## McClellan Air Force Base

Basewide Groundwater Operable Unit

# Groundwater Operable Unit Remedial Investigation/ Feasibility Study Report

**SUBJECT:** Groundwater (GW) Operable Unit (OU) Final Remedial Investigation/Feasibility Study (RI/FS) Document

**FIGURE E-8  
MONITORING AND EXTRACTION**

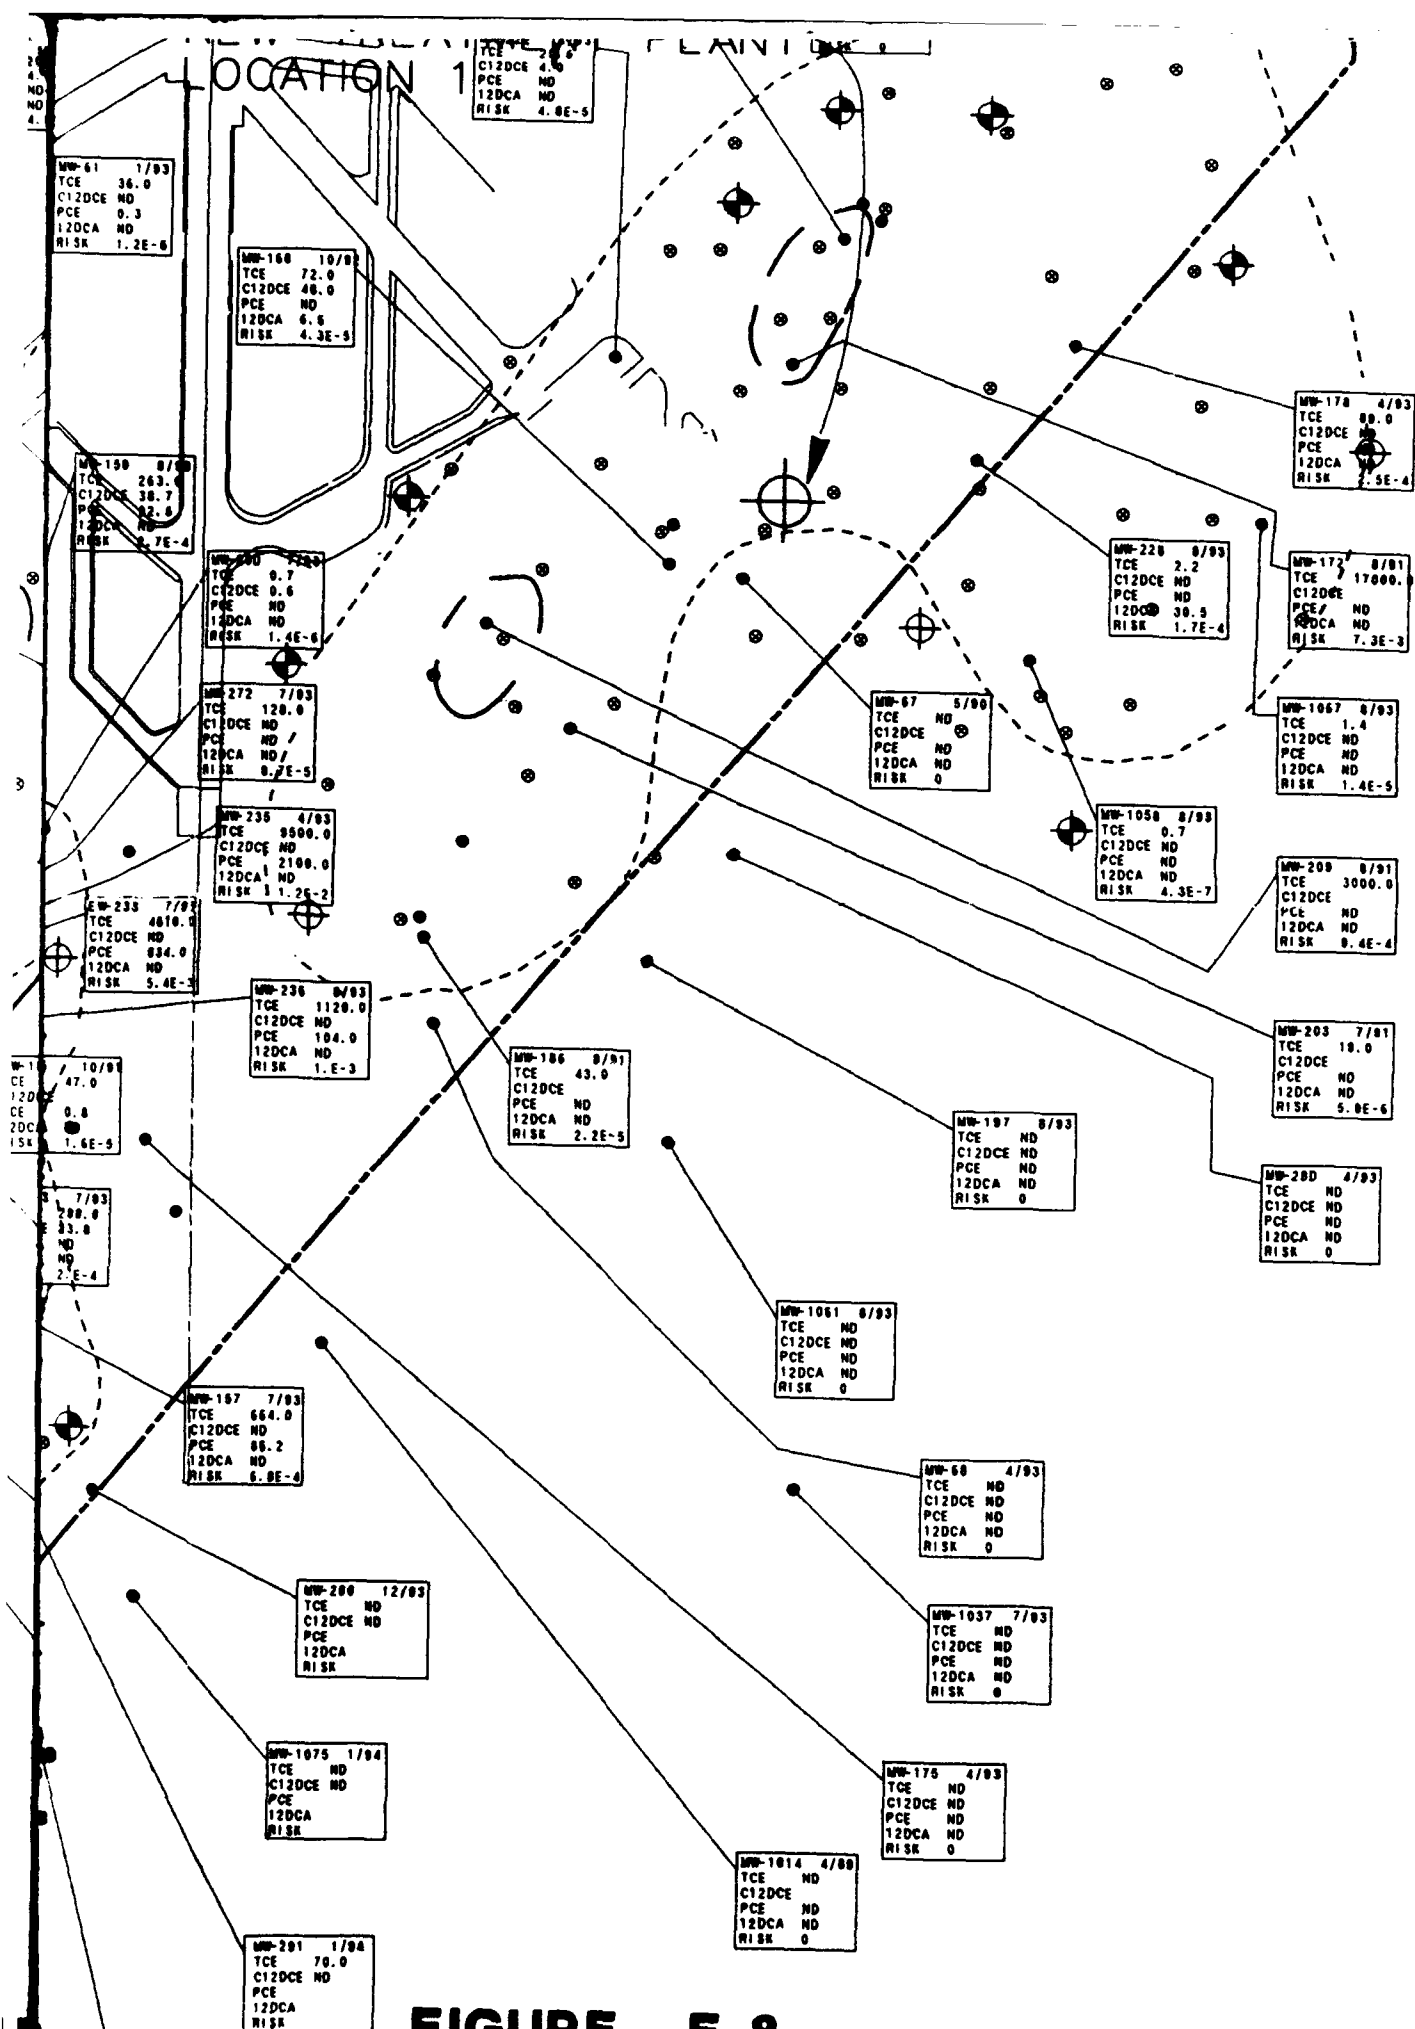
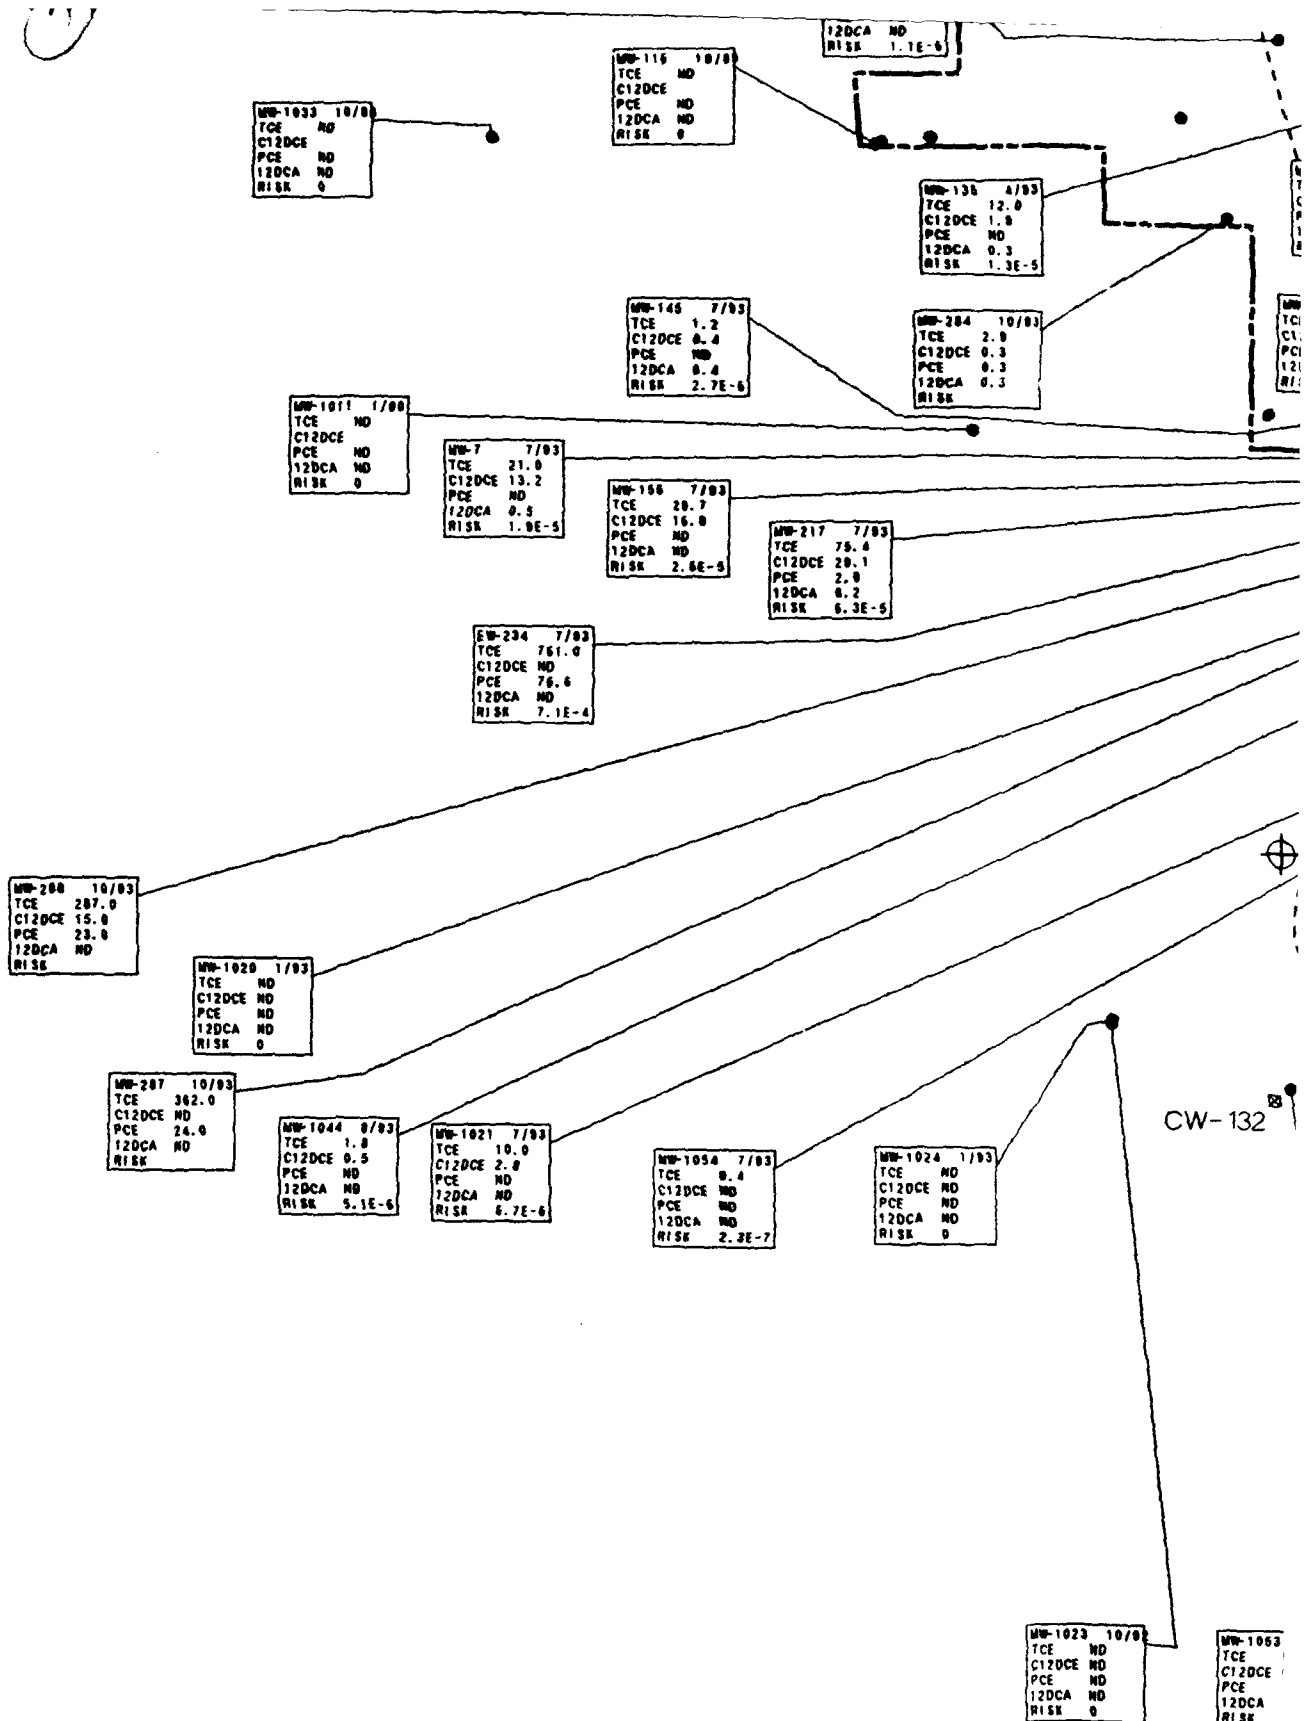
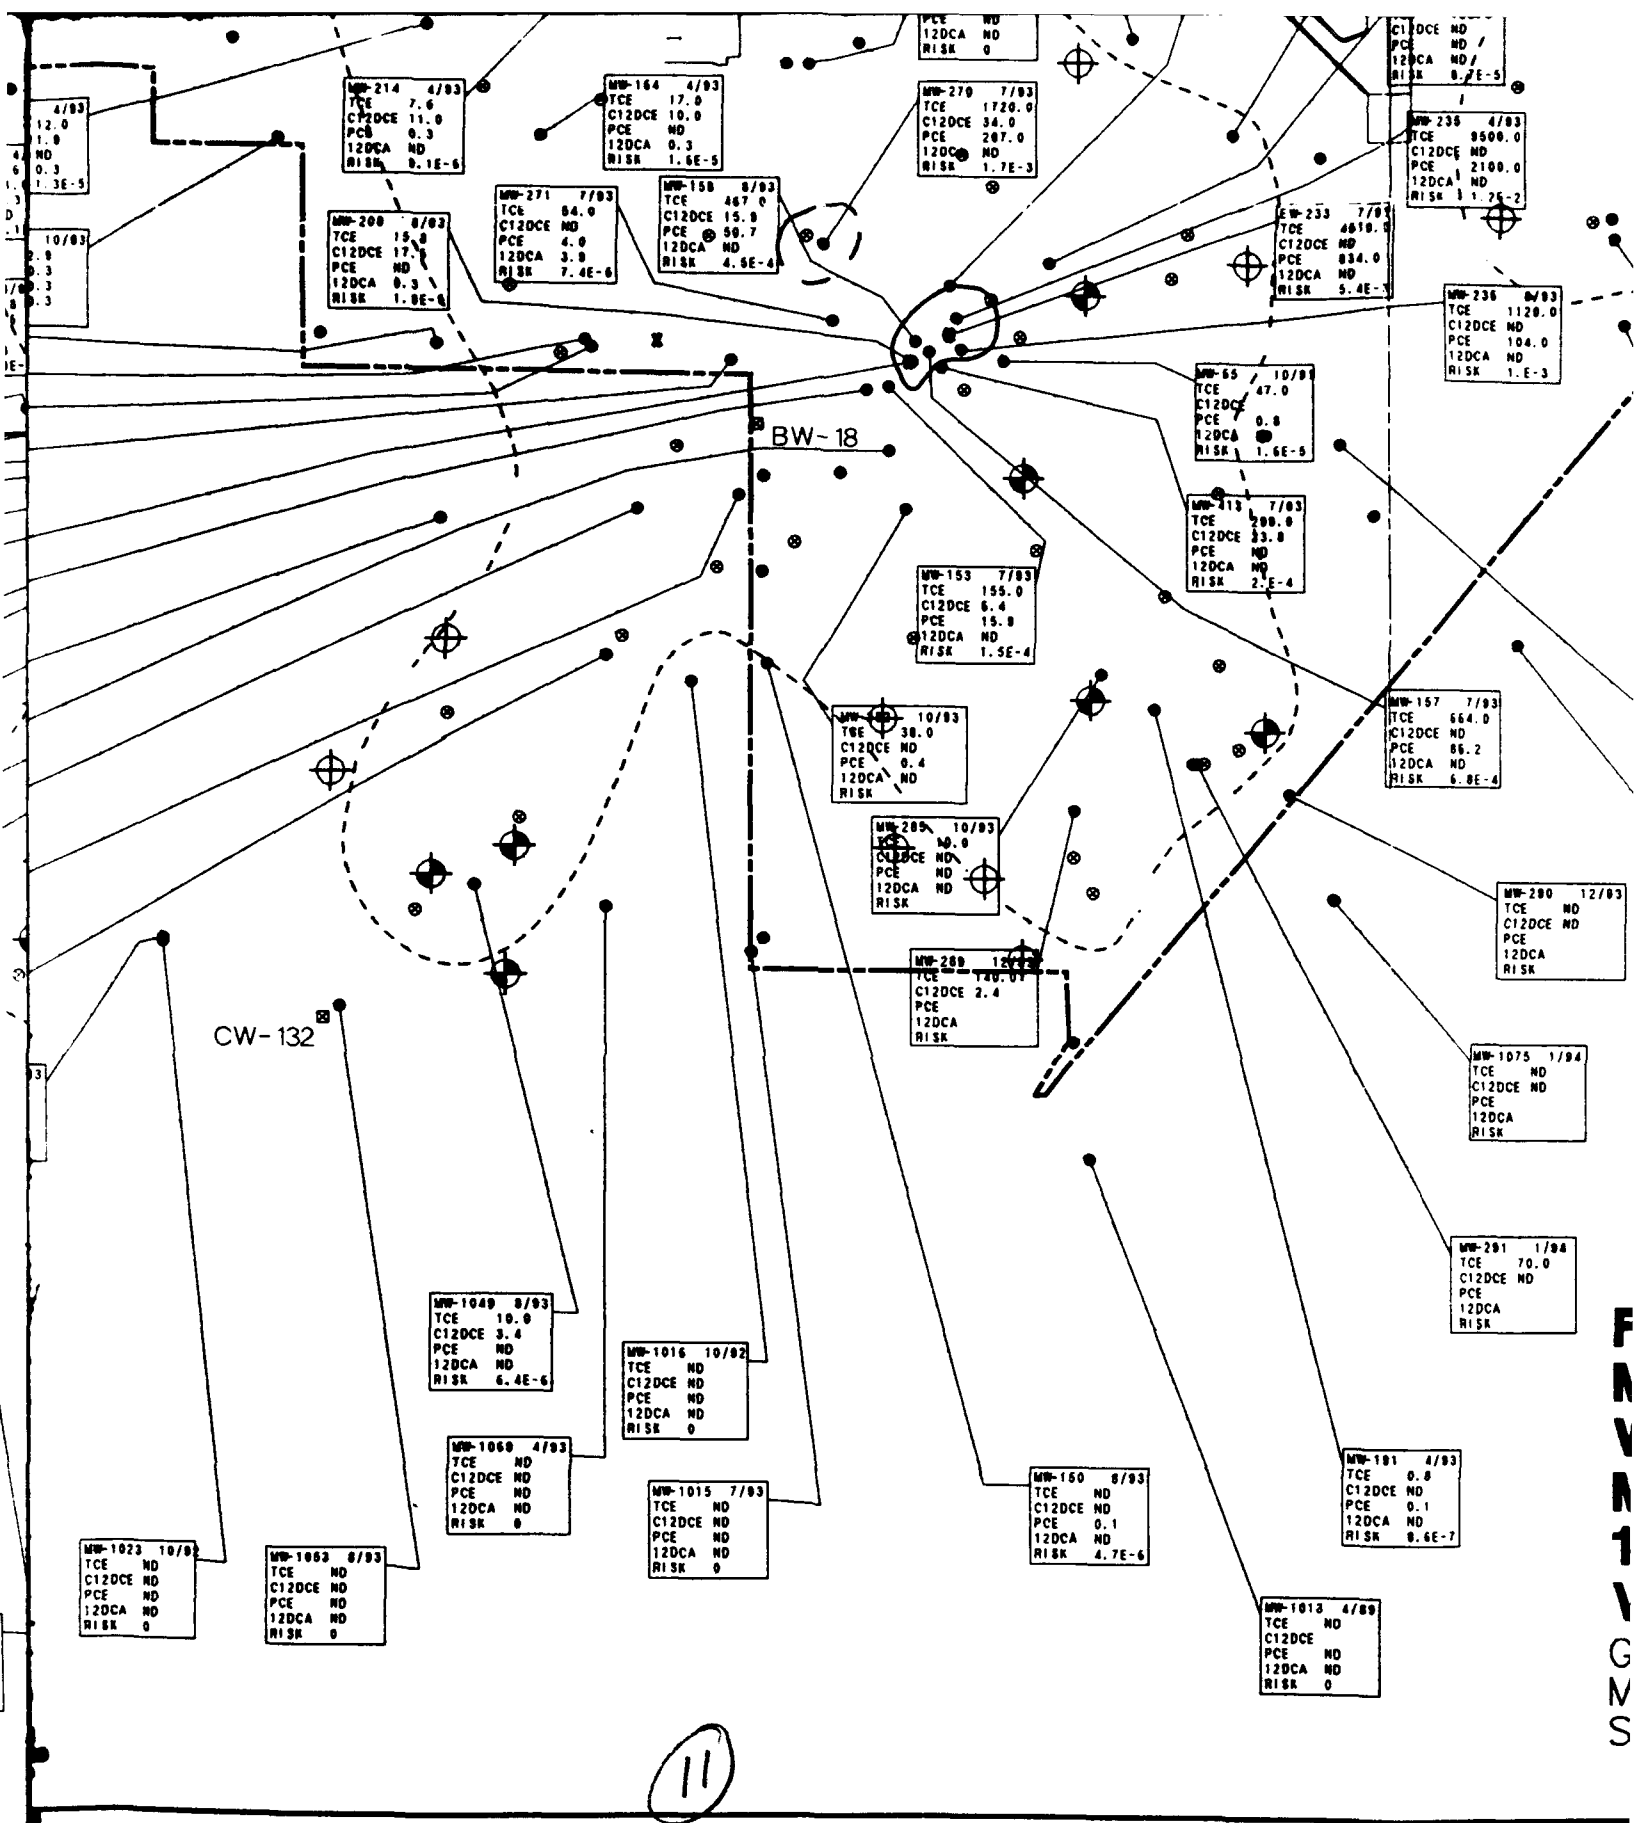
**Figures E-8 and E-9. The text described the need to monitor between the A and B zones in OU-C. Neither figure proposes additional wells suggested by the text. The figures do not indicate additional wells to further define the plume emanating from OU-C1 in the B zone. The maps do not identify the OU-B EE/CA wells, or indicate the need for extraction wells around the OU-B base perimeter to prevent off-base migration when BW-18 is decommissioned.**
